**DOCKET
93-AFC-2**

Procter & Gamble Cogeneration Project

**RESPONSES TO HAZ MAT-5 AND EFFICIENCY-2 DATA REQUESTS FOR THE
PROCTER AND GAMBLE COGENERATION PROJECT (DOCKET NO. 93-AFC-02).**

**RESPONSES TO CEC DATA REQUESTS
(Set 2, dated February, 16, 1994)**

SACRAMENTO COGENERATION AUTHORITY
 PROCTER & GAMBLE COGENERATION PROJECT
 AMMONIA STORAGE FACILITY

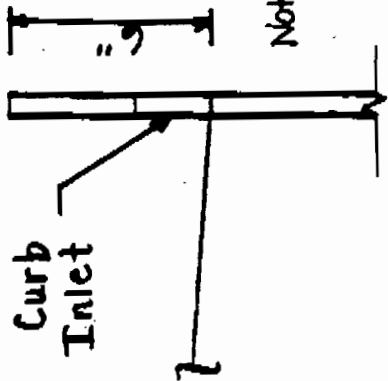
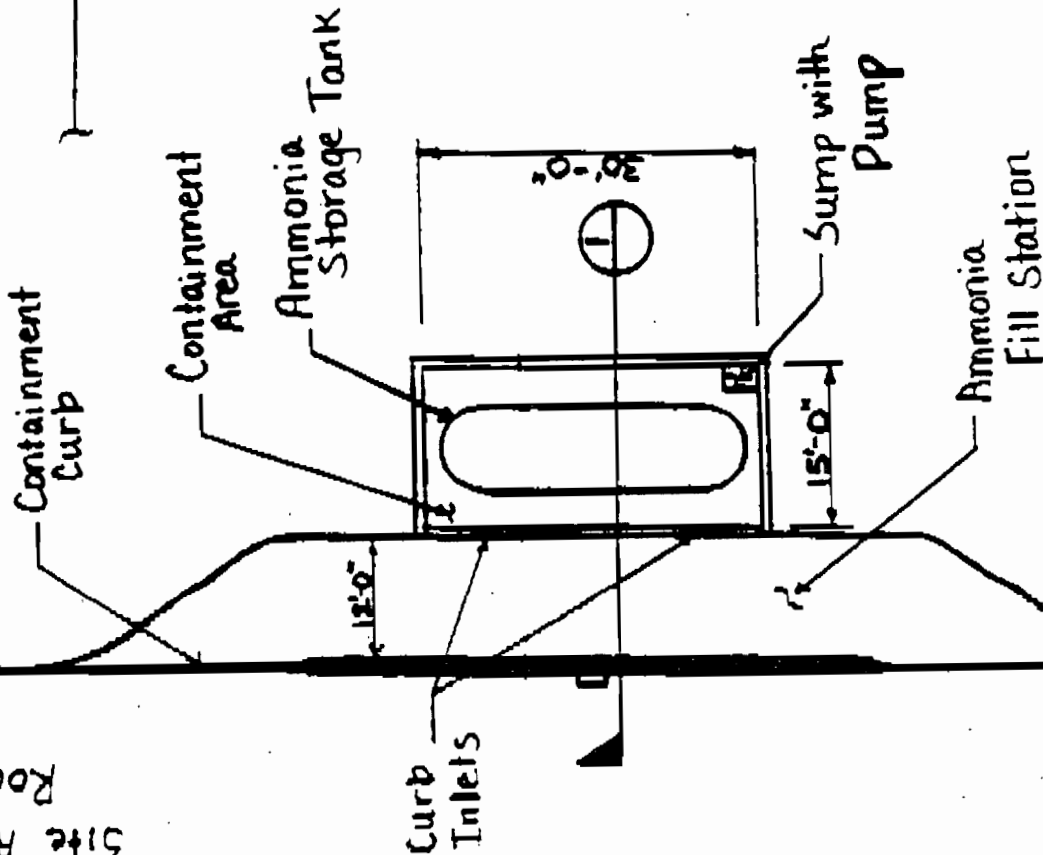
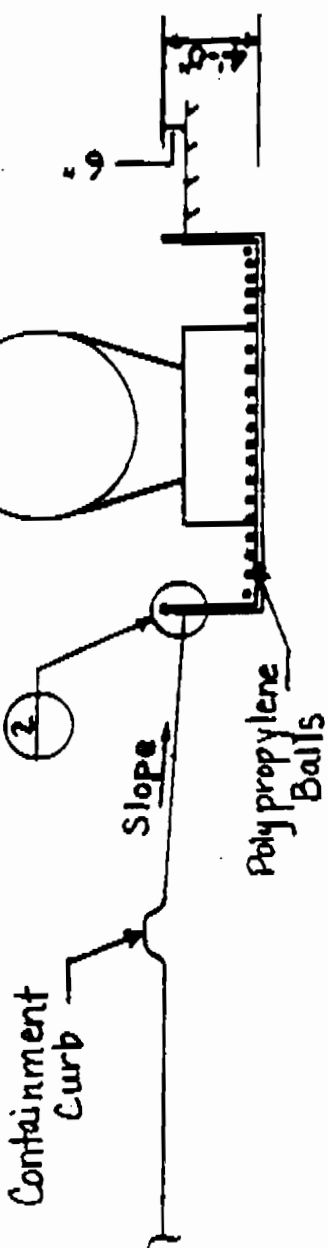
The following information is needed to assess the impacts of accidental release of ammonia during loading operations. The responses to data request HAZ MAT-2 and HAZ MAT-3 described a spill containment area consisting of a bermed apron and drain leading to a neutralization system. Staff cannot verify that the drains and/or the neutralization system are sufficient to contain a worst case release. The requested information is needed to evaluate the potential impacts of an accidental release of ammonia on the public.

Please provide the following information on and preliminary design drawings of the chemical drains and neutralization system. This should include a description of:

- a. the size and capacity of the drains and their ability to handle a worst case spill.
- b. the neutralization system such as location, transport mechanism of spilled material through the system, capacity, speed of treatment, possibility and prevention of overflow.
- c. containment of spilled material if the drains clog or the neutralization system backs up.

The ammonia storage facility will consist of a truck unloading station and a tank containment area. The ammonia unloading station will be curbed and will be provided with curb inlets which will route spills in the unloading area to the tank containment area. (See attached drawing of ammonia storage facility.)

The containment area will be a concrete pit and will be approximately 30 ft long by 15 ft wide and 4 ft deep. The containment wall will extend 12 inches above grade. The containment area will not contain floor drains.

The ammonia storage tank will be a horizontal 10,000 gallon tank which will allow storage of 1.5 times the volume of a delivery truck. The size of the containment area will allow for capture of 100 percent of the storage tank contents or 100 percent of the contents of a truck. The volume of the storage tank would be a worst case spill (up to 10,000 gallons).

A sump pump will be installed in the containment area to pump collected rain water to the neutralization tank. Control of the sump pump will be completely manual.

The containment area will contain a floating vapor suppression system. The vapor suppression system will limit the exposed surface area of the liquid ammonia, thereby limiting the vaporization of any spilled ammonia. The specific type of vapor suppression system will be determined during detailed design.

There will be no gravity drains from the ammonia storage containment area. Therefore, containment of an ammonia spill will not be contingent on a properly functioning drains system.
